TA Board of Directors

Meeting of December 4, 2025

Correspondence as of December 3, 2025

**Alpine Rd Corridor project: Comments to Transportation Authority of San Mateo County;
A bicycling perspective**

Current Configuration

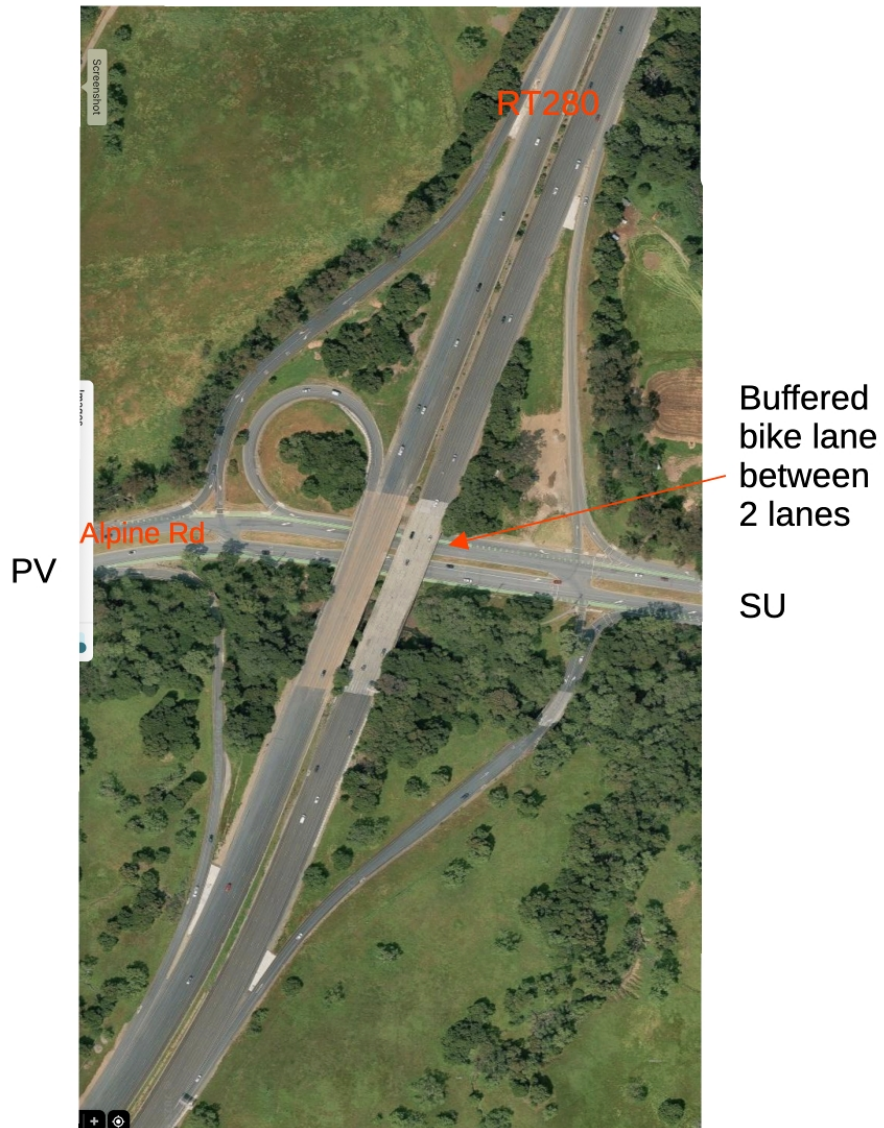
Current configuration: Although the perception of the current layout of the 280 interchange could appear dangerous due to sandwiching a buffered bike lane between two motor vehicle lanes, it works OK. It works because the stop sign meters the traffic in the PV³ bound direction prior to the buffered bike lane. Consequently, at most only three vehicles enter the area beyond the stop sign which makes it easy for each driver (and cyclist) to monitor the other two. And all vehicles are leaving a stop sign at a slow speed. With the existing, green, buffered bike lane, the route of the cyclist is well defined. Motorists can change lanes across the bike lane, but, with the designated bike lane, they know where to expect a bike rider.

Buffered
bike lane
between
2 lanes

Traffic Light Concept; Nov 2025

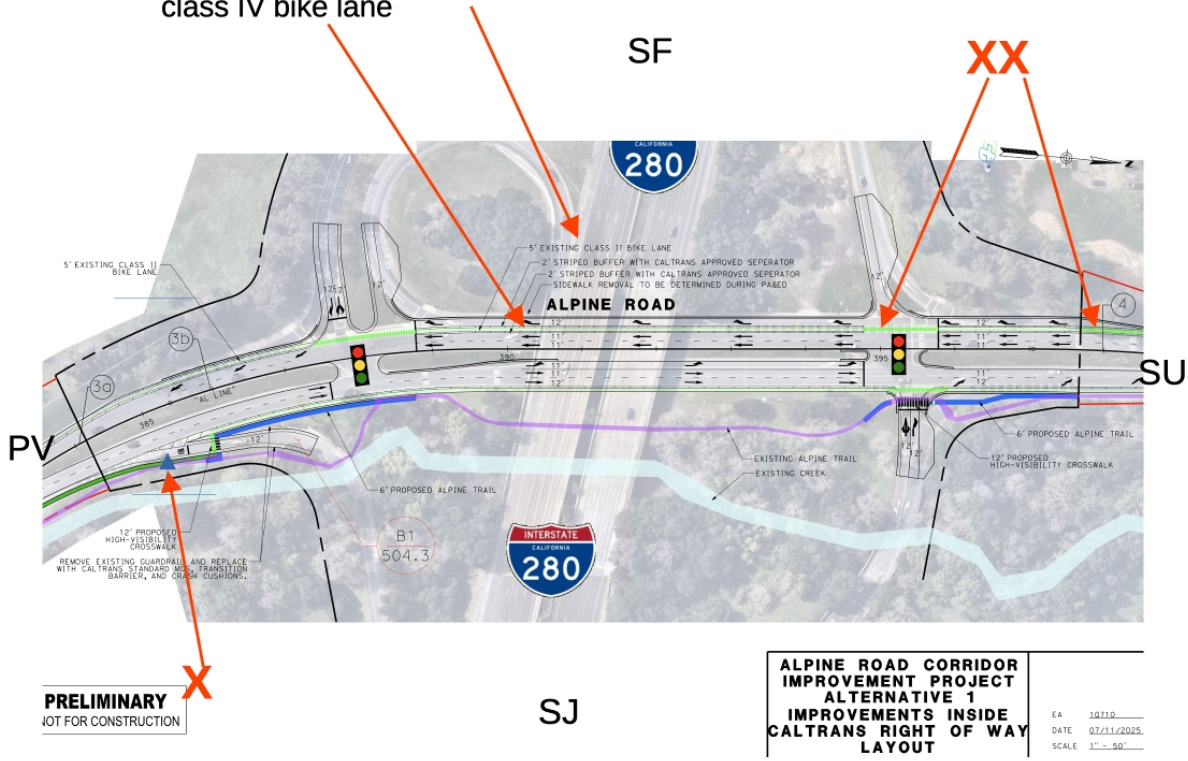
between “Caltrans approved separators” (bollards? K-rails?) on a 5-ft wide bike lane in the PV direction. Note that bicycling speeds can be variable, from a leisurely 5 mph to easily more than 20 to 25 mph. With narrow pathways, safe passing is not possible given the mix of riders, lane positioning, and their bike handling skills.

With the dual traffic-light concept, any motorist headed in the PV direction with the intention of using RT280 will need to be correctly positioned prior to the first stop light. The current usage indicates that more than 50% of traffic using Alpine Rd in the PV direction turns onto RT280 and will need to cross the bike lane prior to reaching the light (denoted by XX in the “traffic light” figure). When the light is green, I can imagine that many motorists will speed-up to get through the intersection before the light turns red; the cyclists could become “collateral damage” from motorist impatience.

Note – separated, narrow, 5-ft wide class IV bike lane

X – conflict area

⁷ The extra room provided by reducing the number of lanes could be used to widen the class IV bike lane in the traffic light alternative.

Roundabout Concept; Nov. 2025

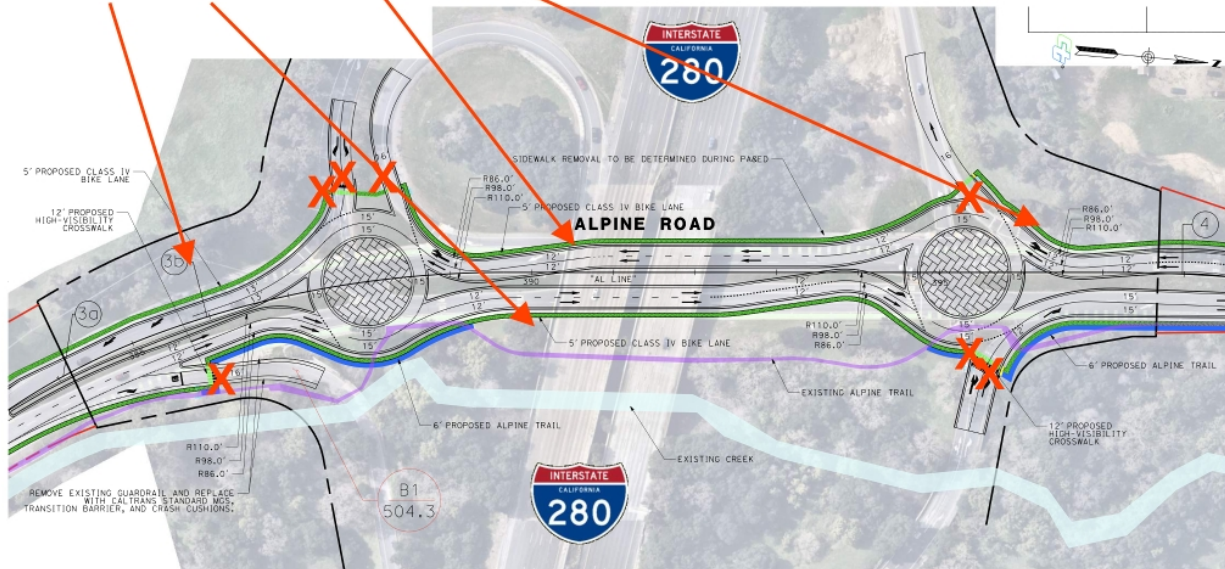
The other problem with the two concepts is the inevitable crossings where bike and cars must negotiate. For the side path option shown with the roundabouts, the concept has bikers crossing the freeway exit and on-ramps using pedestrian crosswalks⁴, coupled with having bikes making 90° turns⁵. In total, bikes will need to cross 4 lanes in the PV direction and 3 in the SU direction. I suspect that many of the current cyclists using Alpine Rd will skip using the side path in favor of navigating the roundabouts⁶. However, two-lane roundabouts are difficult for cyclists to navigate safely with motorists jockeying for position.

5-ft wide side path;
too narrow to
accommodate
bikes going at
different speeds

X – Conflict zone; cross-walks (two X dual lane crossing)
